ADDENDUM # 1

DATE: April 11, 2025

**FOR: PCDL – NEW LEXINGTON
ADDITION & RENOVATION**

1/4"=1'-0"

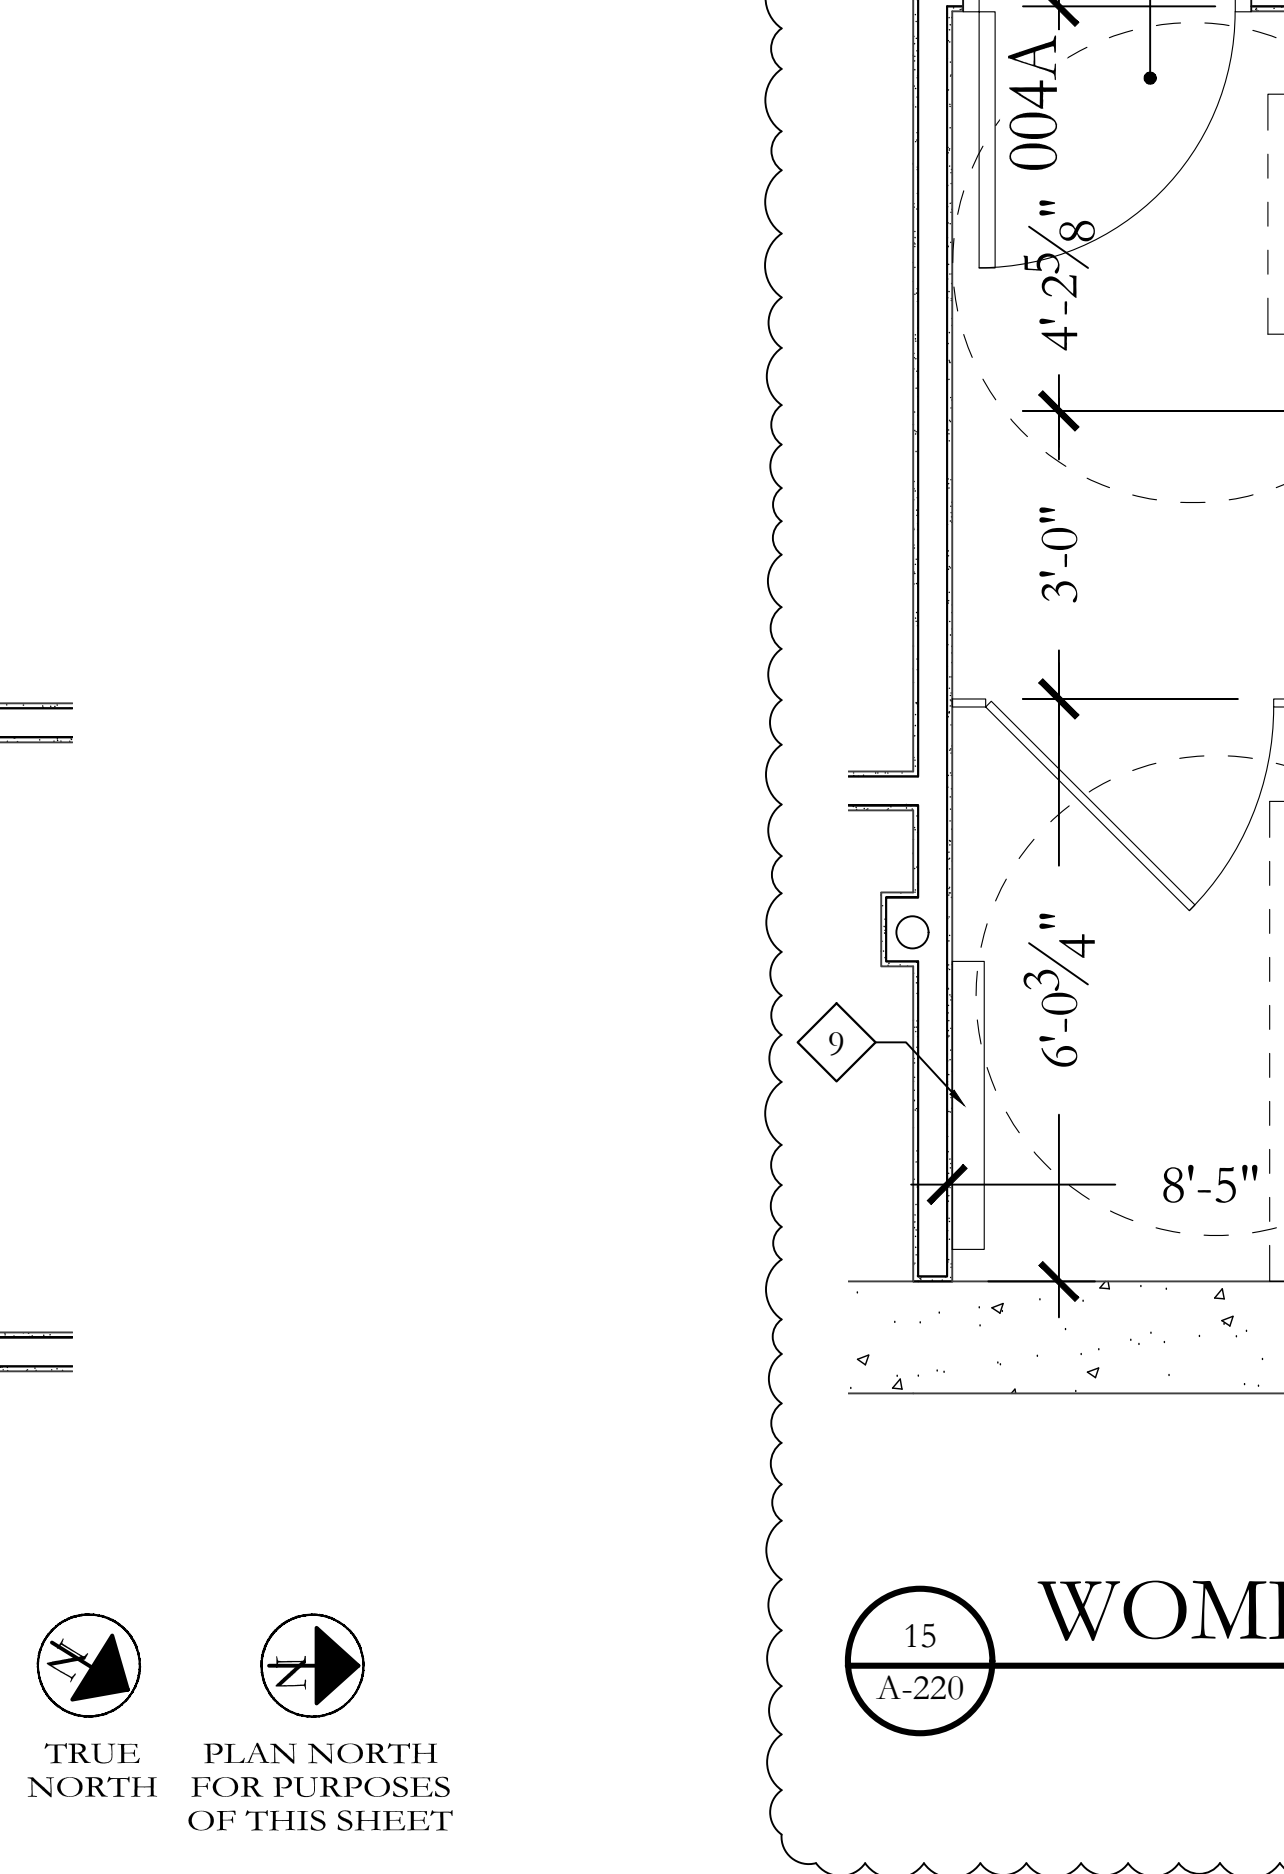
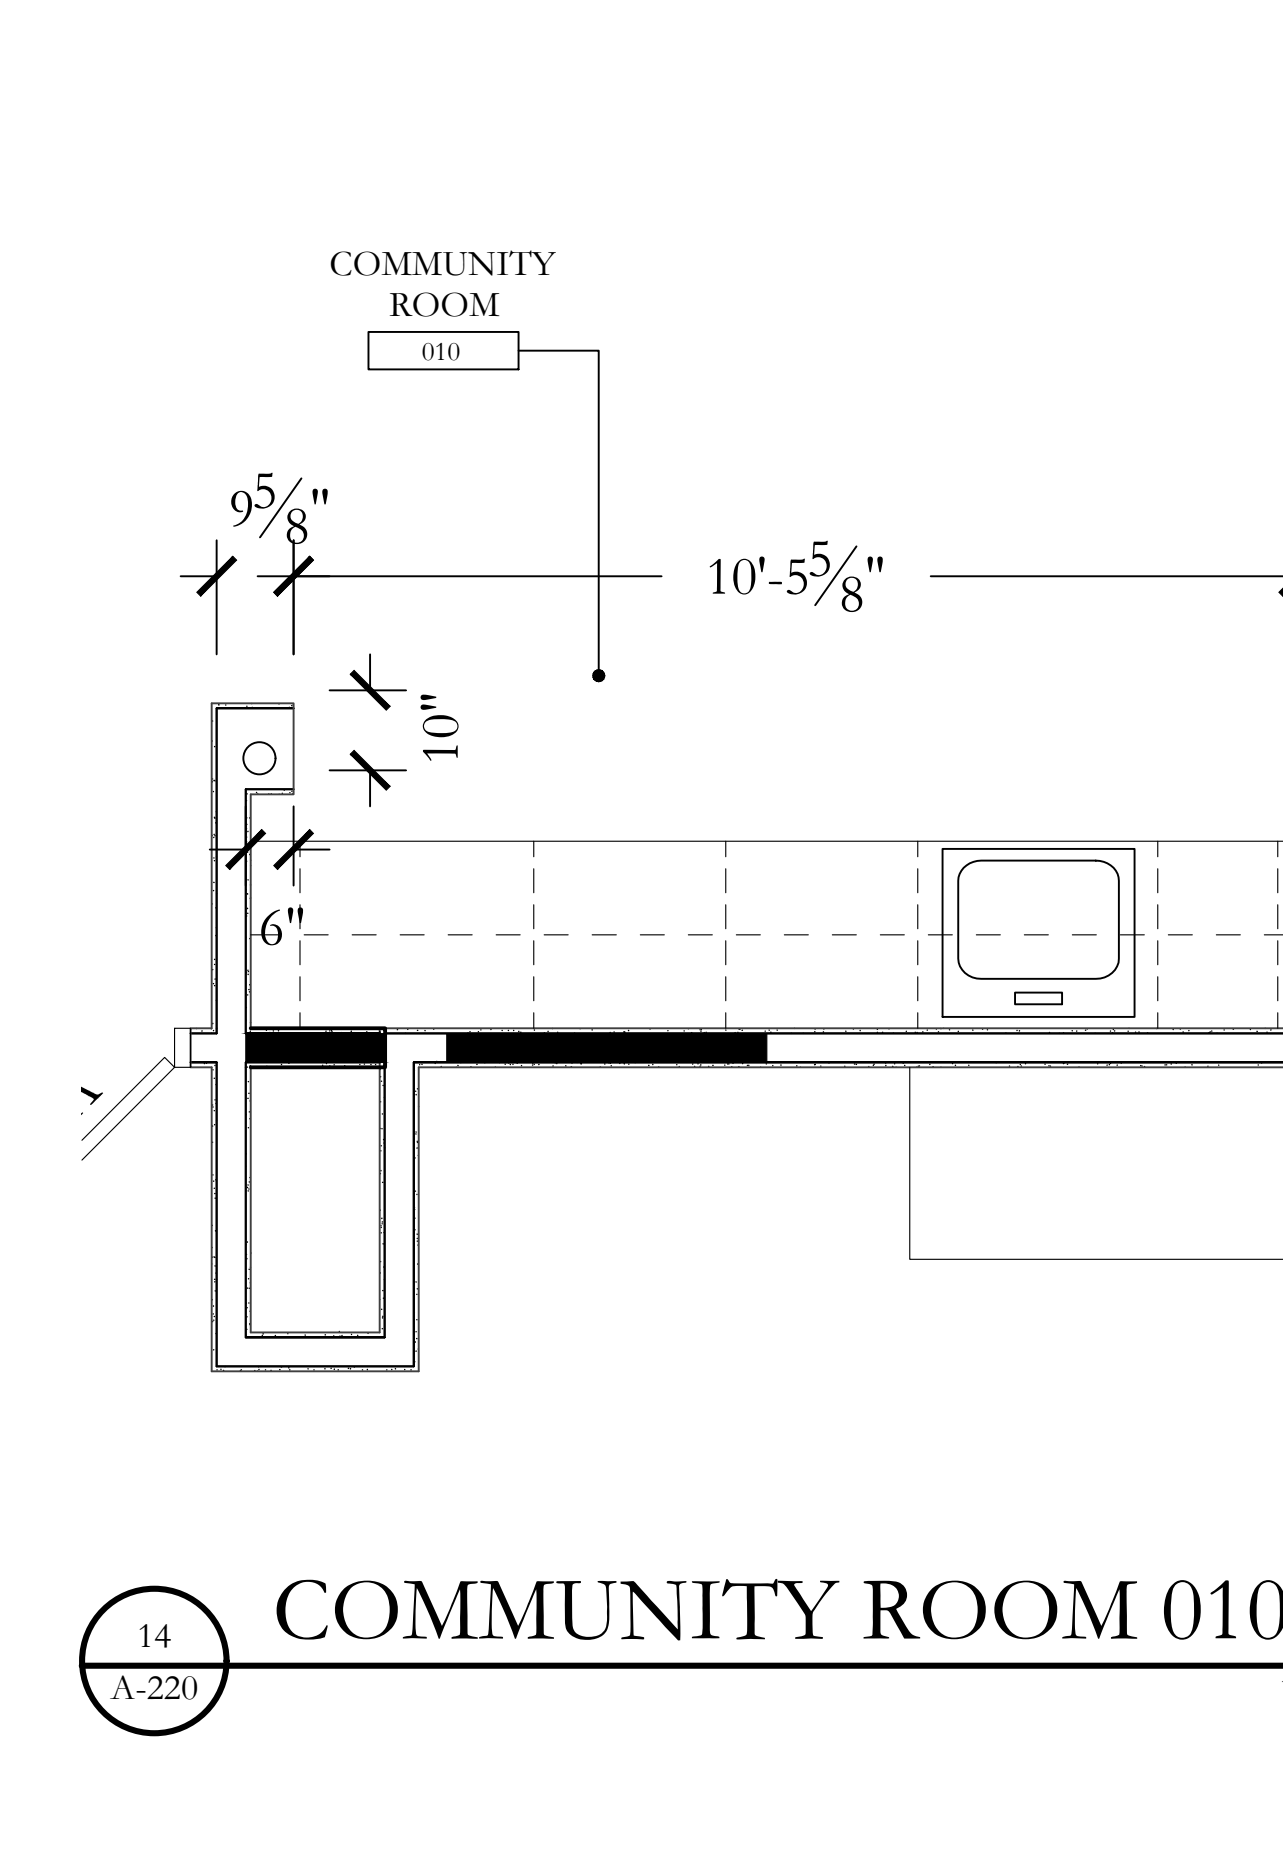
Item #8 Interior Elevations & Enlarged Floor Plans – replace A-220 with attached

- a. Remove paper towel dispensers in restrooms (Women's 004, Men's 005, Women's 103, Men's 104) – Owner will furnish paper towel dispensers, and Contractor will install.
- b. Revised coded notes
- c. Revised interior elevations (Details 1/A-220, 2/A-220, 5/A-220, 8/A-220, 10/A-220, & 11/A-220)
- d. Revised enlarged plans (Details 15/A-220 & 16/A-220)

LOWER LEVEL POWER PLAN
SCALE: 3/16"=1'-0"

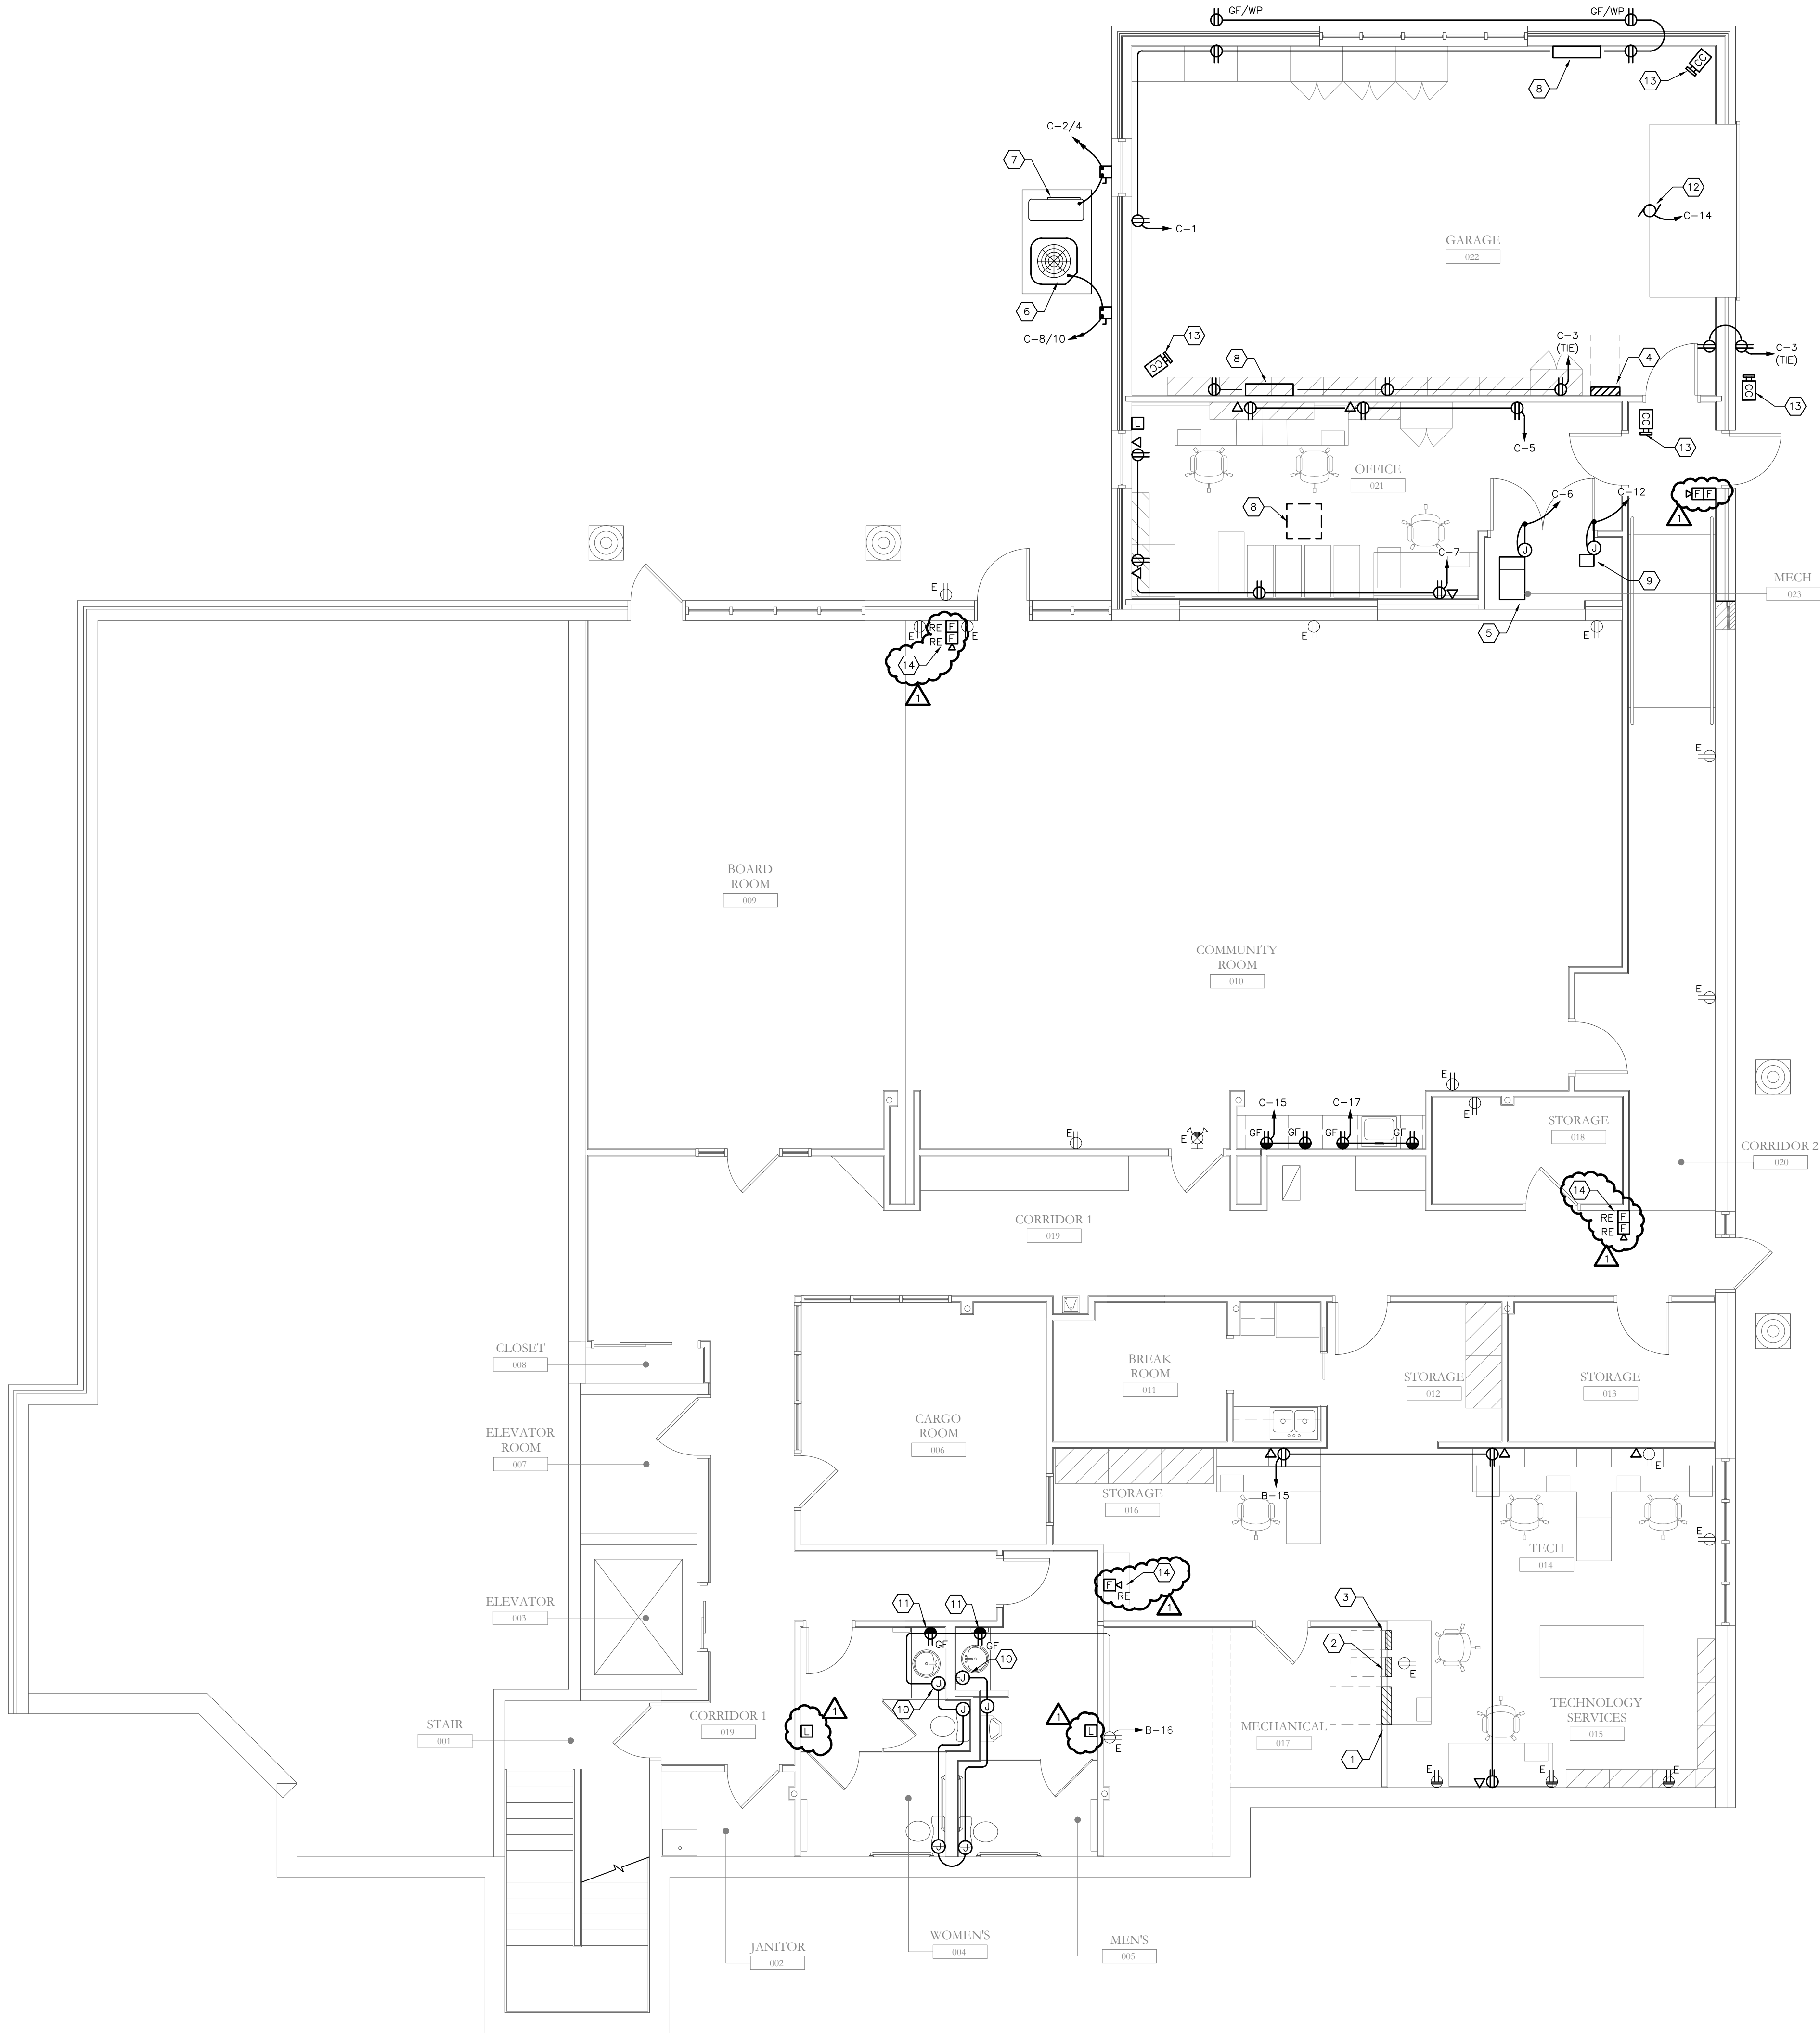
Item #2 Lower-Level Power Plan – replace E-201 with attached

- a. Revised plan notes
- b. Relocated fire alarm devices from lighting sheet (E-101) to this sheet
